Access Compliance Report

Public Rights-of-Way

Intersection ID: 13056	Main Street: S_MINT_ST	Cross Street: W_BLAND_ST	Location: S
ADA ID: B66F23DCA08F	Ramp Type: BlendTrans2	Initial Pass/Fail: Fail	Overall Compliance: No
		Severity Score: 10

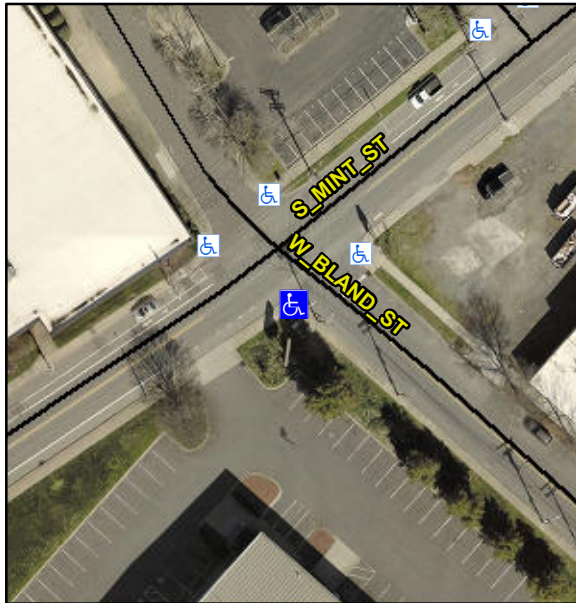
R304.5.1, R304.5.3

Compliance	Description	Data	Compliance	Description	Data
N/A	Ramp Length (in)	60.0	Yes	BlendTrans Slope (%)	2.9
No	Ramp Width (in)	40.0	No	BlendTrans XSlope (%)	2.2
N/A	Flare Type LT	N/A	N/A	Flare Type RT	N/A
N/A	Flare Slope LT (%)	N/A	N/A	Flare Slope RT (%)	N/A
N/A	Flare Traversable LT?	N/A	N/A	Flare Traversable RT?	N/A
N/A	Landing Length (in)	N/A	N/A	DWS Provided?	N/A
N/A	Landing Width (in)	N/A	N/A	DWS Contrast?	N/A
N/A	Landing Slope (%)	N/A	N/A	DWS Length (in)	N/A
N/A	Landing X Slope (%)	N/A	N/A	DWS Full Width?	N/A
N/A	Landing Curb? (Y/N)	N/A	N/A	DWS Offset (in)	N/A
N/A	Shared Landing?	N/A			
N/A	Gutter Ponding?	N/A	N/A	Gutter Slope (%)	N/A
N/A	Gutter Lip Ht (in)	N/A	N/A	Gutter X Slope (%)	N/A
N/A	Painted X Walk1?	No	N/A	Painted X Walk2?	No
	X Walk 1 Direction	To NE		X Walk 2 Direction	To NW
	X Walk 1 Width (in)	N/A		X Walk 2 Width (in)	N/A
	X Walk 1 Slope (%)	2.7		X Walk 2 Slope (%)	1.6
	X Walk 1 X Slope (%)	0.6		X Walk 2 X Slope (%)	0.7

Remove & Replace Curb Ramp With Two New Directional Ramps or Equivalent.
